RECALL 18V-336: REPLACE BELT DRIVE IDLER PULLEY BOLT

This Service Information bulletin replaces SI B12 19 18 dated **February 2019**

E70 (X5 xDrive35d)

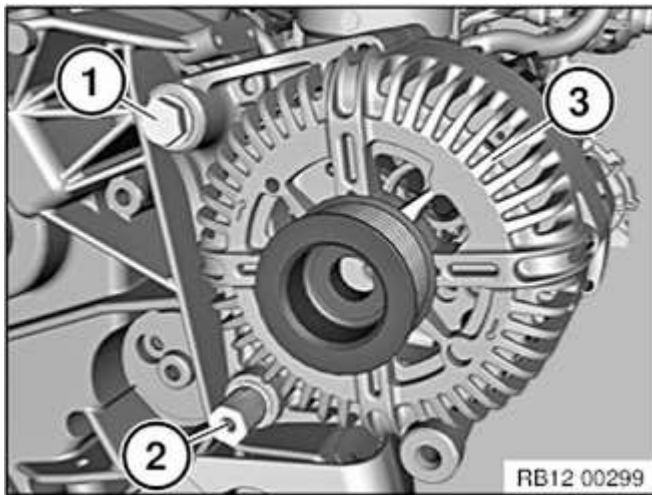
- Exploded view of cover (1) pulley bolt (2) and pulley (3). These parts are not to be reused.

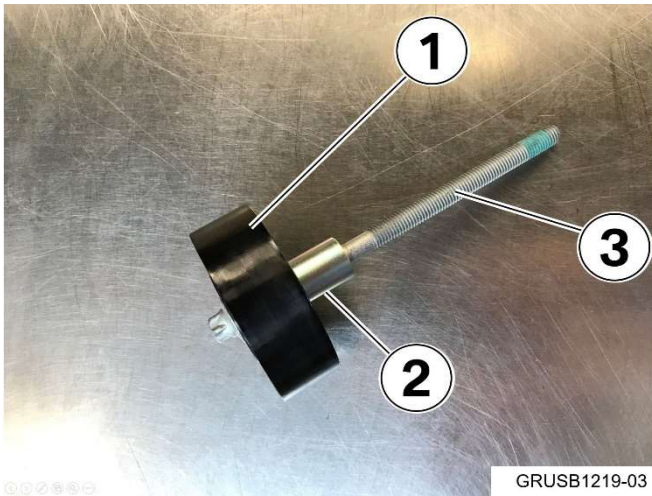
- New parts to complete the recall: New alternator bolt (1), spacer for the idler pulley (2) and new idler pulley with cover (3).

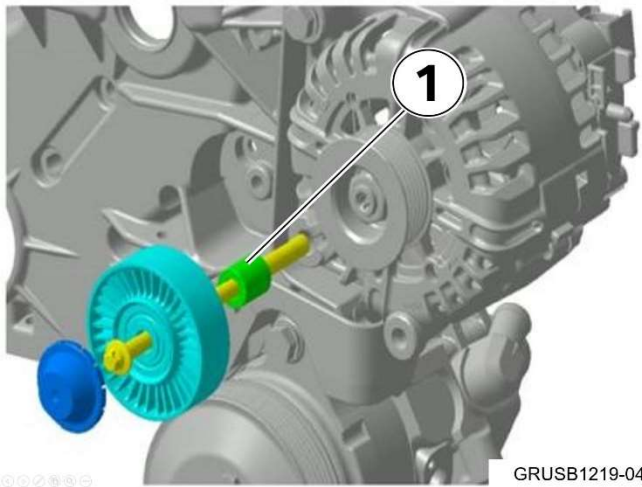
- Assemble the new idler pulley (1) and spacer for the idler pulley (2) on the new bolt (3).

- Install the bolt with spacer and pulley (1) into the alternator bracket.
- Tightening torque for new bolt:
Jointing torque: **38 Nm**
Angle of rotation: **90°**
Angle of rotation: **90° (180° total angle rotation)**
